Site: Land At Coombe Hill Road, East Grinstead, West Sussex
Prepared by: Phil Allen MCIWEM C.WEM
Approved by: Neil Jaques
Date: 16 March 2026

1.1 This technical note has been prepared to discuss and provide the additional information that has been requested by West Sussex County Council (WSCC) as the Lead Local Flood Authority (LLFA) in their holding objection to DM/26/0073.

1.3 This technical note will deal with each of the three points raised by WSCC as the LLFA in turn below.

Title:
Drainage Strategy Plan

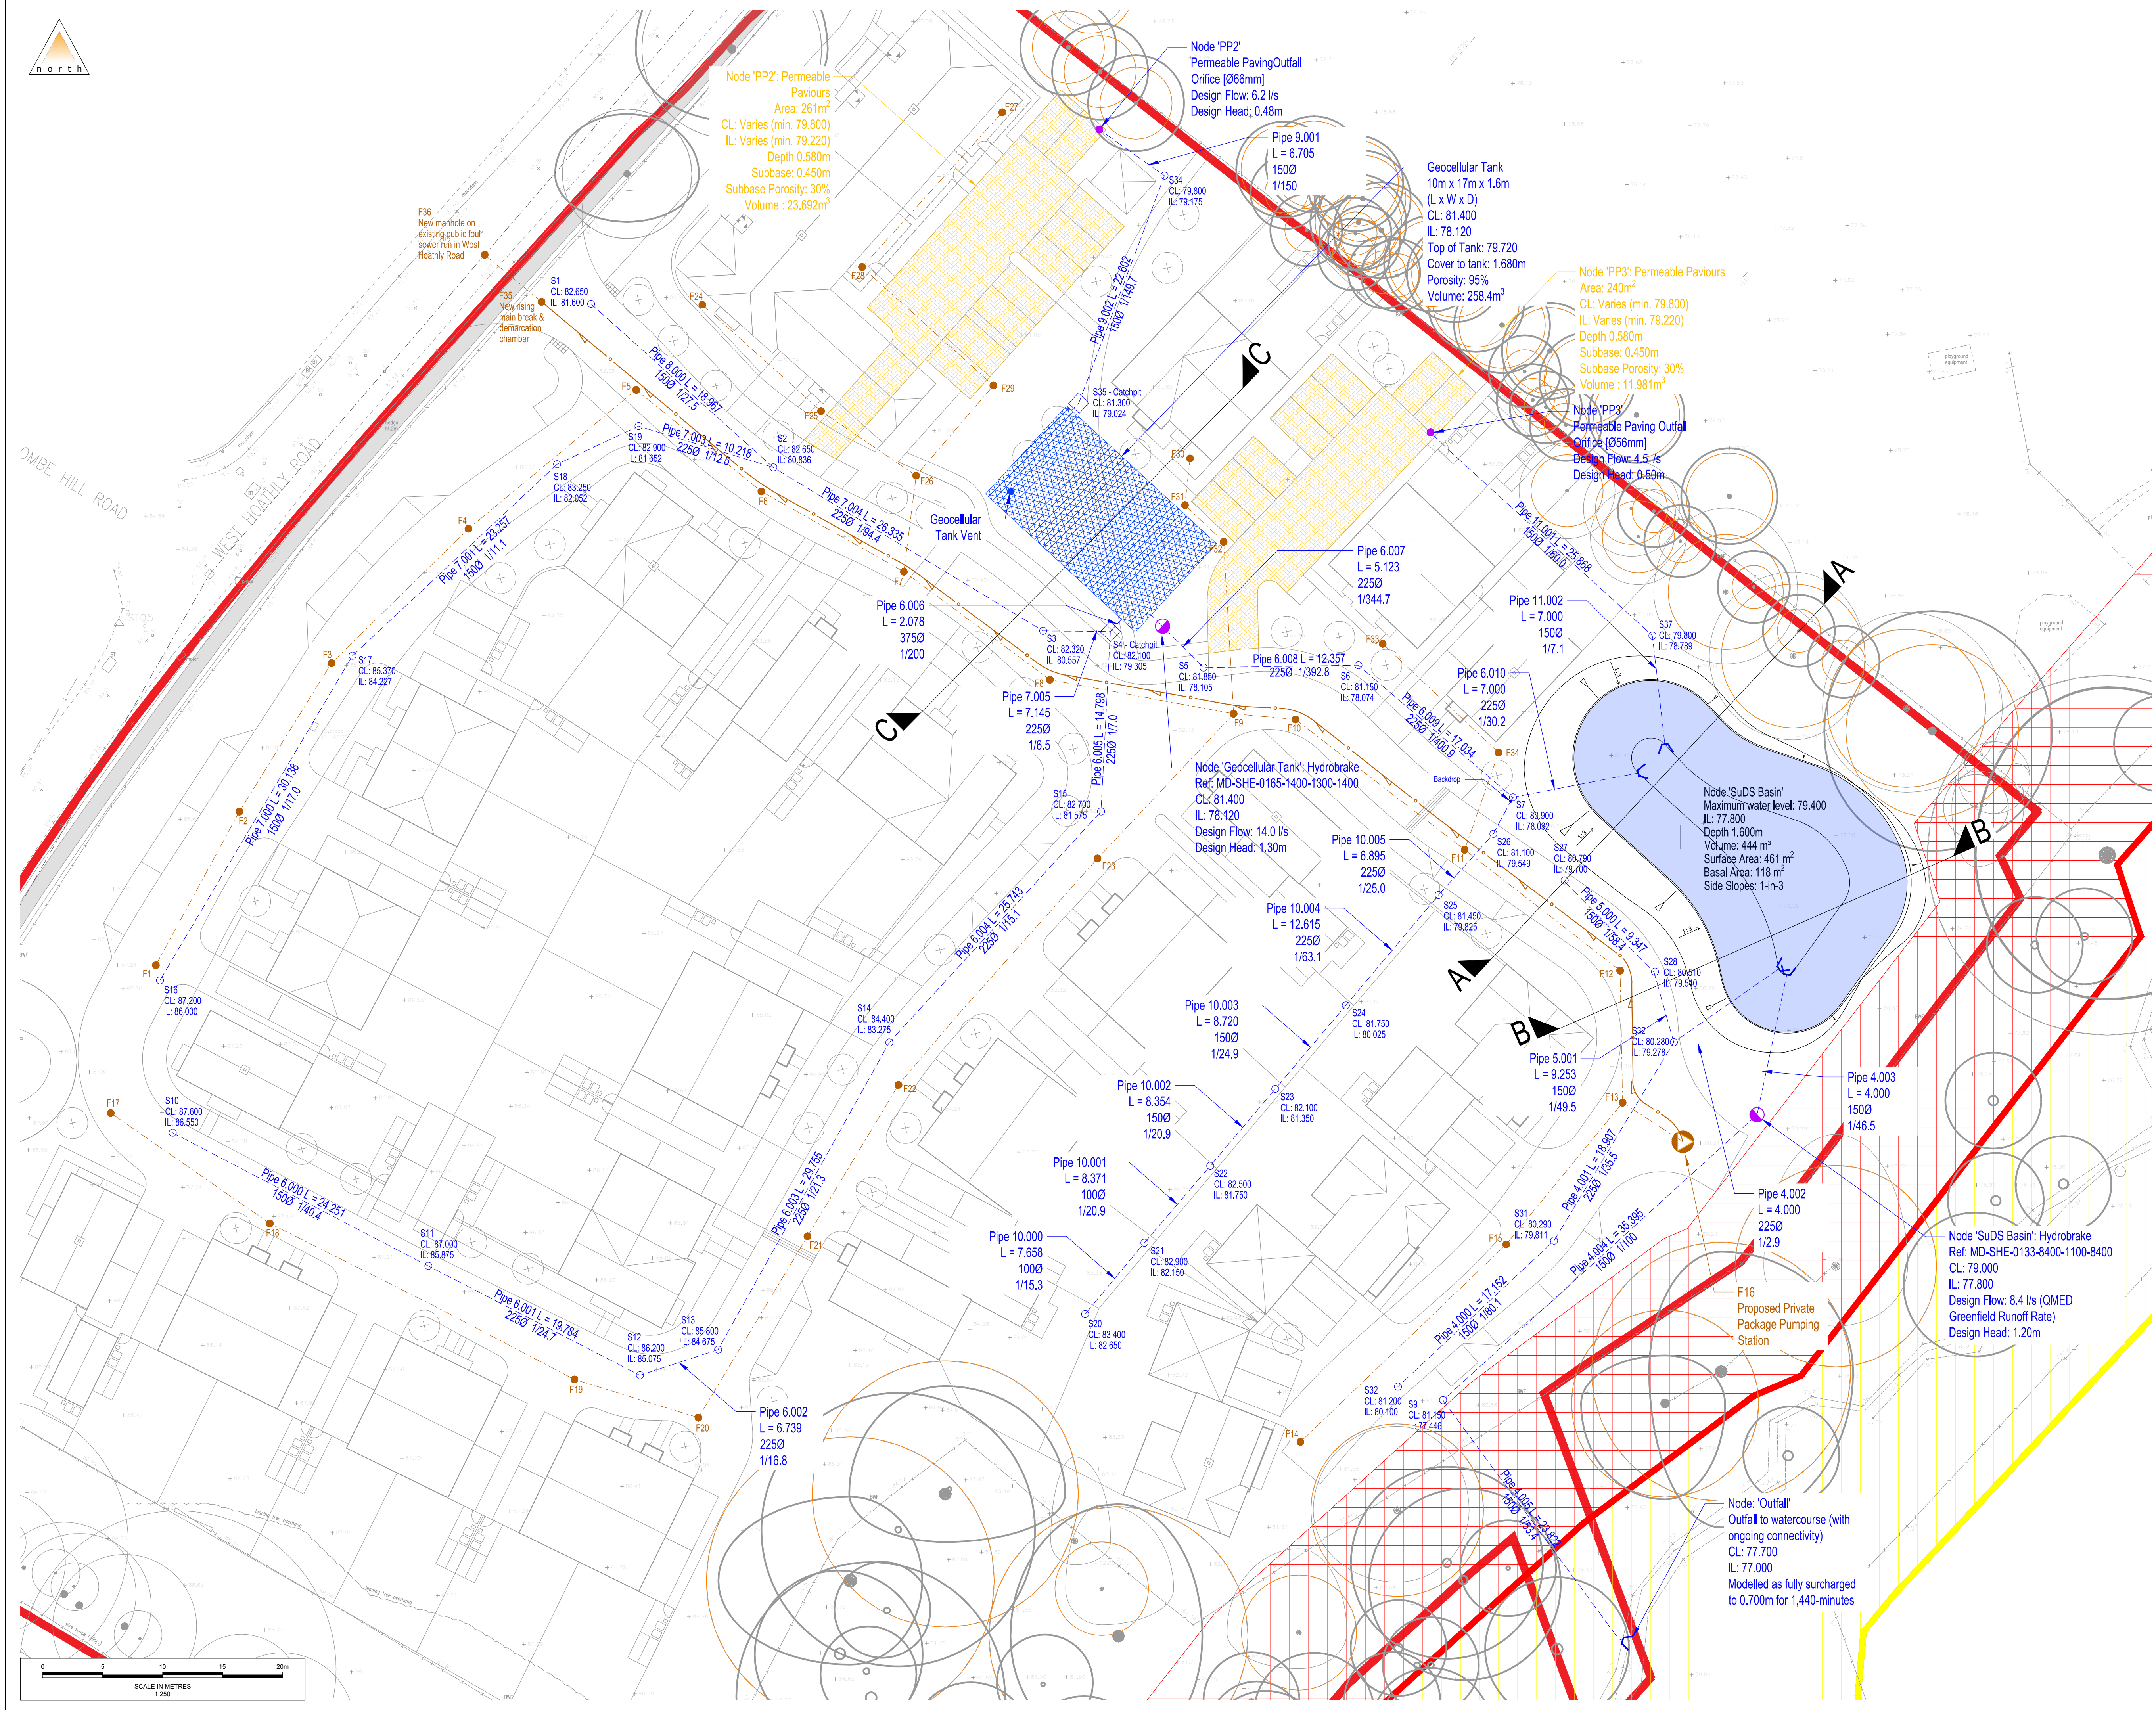
Cross sections of any SuDS features should be provided on any final layout drawings along with clear 3m easements annotated from any structures or watercourses and any natural directions of flow (sub dividing any catchments).

- 2.7 Cross-sectional information of the SuDS has been provided in **Appendix B** of this report to provide further information to the detailed drainage information supplied in the drainage strategy plan.
- 2.8 The site is a single catchment.
- 2.9 The receiving watercourse flows from south to north and its place within the wider hydraulic network can be seen in Google Maps and other mapping products.

- 2.10 Regarding three metre easements, these have been provided on three out of four sides. As a note on this, the National Standards for SuDS require SuDS to be designed for safe operation, inspection and maintenance across their life, but do not prescribe any fixed maintenance strip width. Similarly, CIRIA C753 is explicit about designing maintenance access to inlets/outlets and areas where silt may accumulate and about enabling landscape machinery access (e.g., for grassed basins), but it does not require a continuous three metre easement around all sides; rather, it promotes the need for practical access routes/tracks and working areas sized for the machinery that is expected, with adequacy being assessed via the design and maintenance checklists. And, finally, the DCG (Appendix C, 2023 v2.3) requires that SuDS offered for adoption are maintainable with safe access, but does not mandate a three-metre strip around every side

- 2.11 With the above in mind, the maintenance access and easement to the SuDS and drainage features is suitable, adequate and in line with industry guidance and best practice.
